CD Autochanger – Transit Screws –
Storage Location

MODEL 1995-96 MY
Sedan Range
VIN
720001-ON

ILLUSTRATION 1

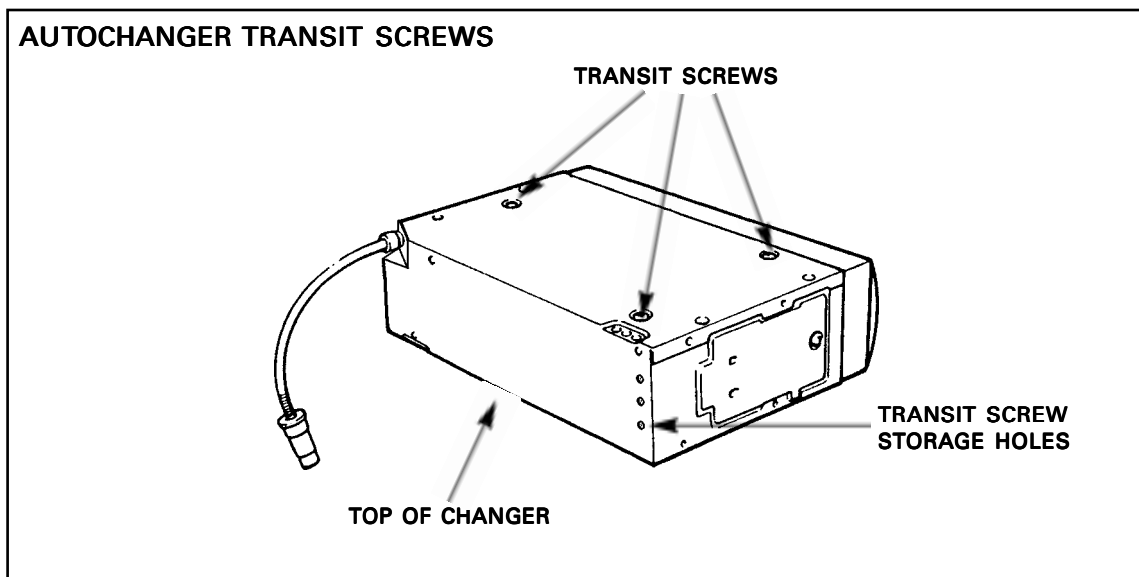
Starting with VIN 787300, these screws should be placed in the storage holes now provided on the rear face of the unit.

The storage location is shown in Illustration 1.

When removing the CD Autochanger for repair or replacement, **reinstall all three** transit screws into the three holes on the bottom of the unit, before the Autochanger is packed for shipping.

NOTE: Correct installation of **all three** transit screws is essential to prevent damage to the mechanism during shipping.
